Re: San Lorenzo River Trestle Bridge

Walkway

Thursday 9/13/18 Coastal Permit Application # 3-18-077

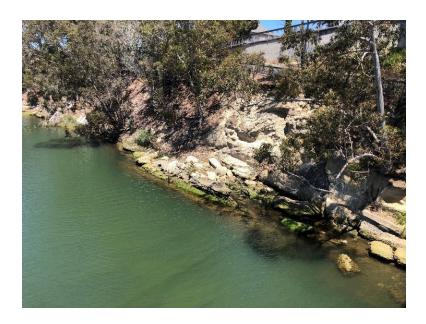
3. On page 13 c. The city minimizes the shade on the river from the trees in its photo. In the photo below (from the Sierra Club/jane mio) you can see the more accurate shade value (for fish) of the trees compared to the second photo (City, MND).
